# Service Bulletin

Bulletin No.: PIP5156

**Subject:** Possible Oil Leak On Gen 5 Engine After The Harmonic Balancer Is Removed Or Replaced

**Models:** 2014 Chevrolet Corvette  
2014 Chevrolet Silverado 1500  
2014 GMC Sierra 1500  
Built with RPOs 4.3L 5.3L 6.2L L83 L86 LT1 LV3

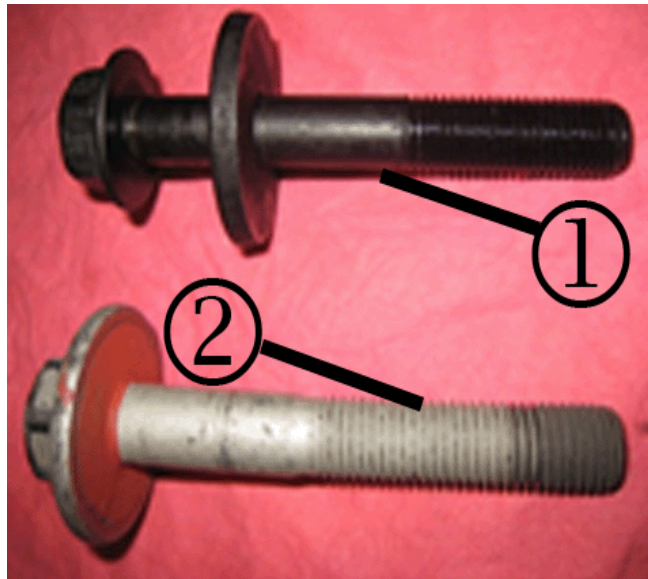
- Gen 4 engines use a non-keyed Harmonic balancer. The only part of the crank that is keyed drives the oil pump. The bolt has a friction material on the face. It does not seal the Harmonic Balancer to the crank.
- Gen 5 engines use a keyed Harmonic Balancer that can see oil pressure. It uses a two piece bolt and washer arrangement. It does seal to the face of the crank.

**Note:** If you use a Gen 4 bolt in a Gen5 engine you will have an oil leak.

1- is for a gen 5 engine

2- is for a gen 4 engine
